NUCLEAR REGULATORY COMMISSION

Exelon Generation Company, LLC; LaSalle County Station, Units 1 and 2

ACTION: Environmental assessment and finding of no significant impact; issuance.

Figure 1. Current and Proposed Temperature of Cooling Water Supplied to the Plant from the CSCS Pond Versus Time of Day Requirements

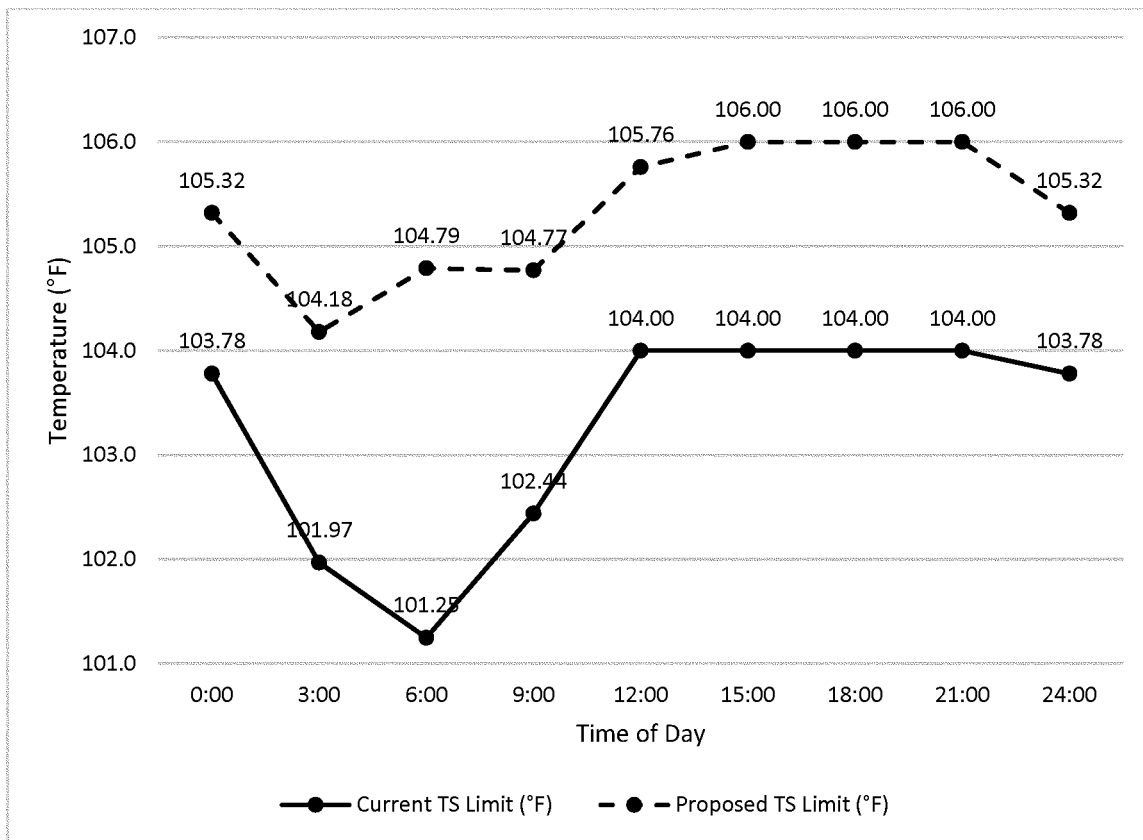
If approved, the proposed action would revise TS Surveillance Requirement (SR) 3.7.3.2 concerning the UHS sediment level verification requirement to allow for an average, rather than absolute, sediment level. The proposed action would also modify the temperature curve associated with TS SR 3.7.3.1 to increase the allowable TS diurnal temperature limits of the cooling water supplied to the plant from the UHS. Other conforming TS changes would also be made.

The proposed action would also modify the temperature curve associated with TS SR 3.7.3.1. This requirement currently states, "Verify cooling water temperature supplied to the plant from the CSCS pond is within the limits of Figure 3.7.3-1." Under the proposed action, Figure 3.7.3-1 would be modified to specify new diurnal temperature limits. The revised TS temperature limits would continue to vary with the diurnal cycle and would continue to limit the maximum temperature of the UHS supplied to plant safety systems to below 107 degrees Fahrenheit ($^{\circ}$ F) (41.7 degrees Celsius ($^{\circ}$ C)), the design limit of the plant. The revised limits would increase the allowable maximum UHS temperature of cooling water by 1.54 to 3.54 $^{\circ}$ F (0.85 to 1.97 $^{\circ}$ C) as compared to current limits and depending on time of day. Table 1 lists the current and proposed temperature limits, and Figure 1 depicts these limits graphically.

Time of day	Current TS limit (°F)	Proposed TS limit (°F)	TS limit difference (°F)
0:00	103.78	105.32	1.54
3:00	101.97	104.18	2.21
6:00	101.25	104.79	3.54
9:00	102.44	104.77	2.33
12:00	104.00	105.76	1.76
15:00	104.00	106.00	2.00
18:00	104.00	106.00	2.00
21:00	104.00	106.00	2.00
24:00	103.78	105.32	1.54
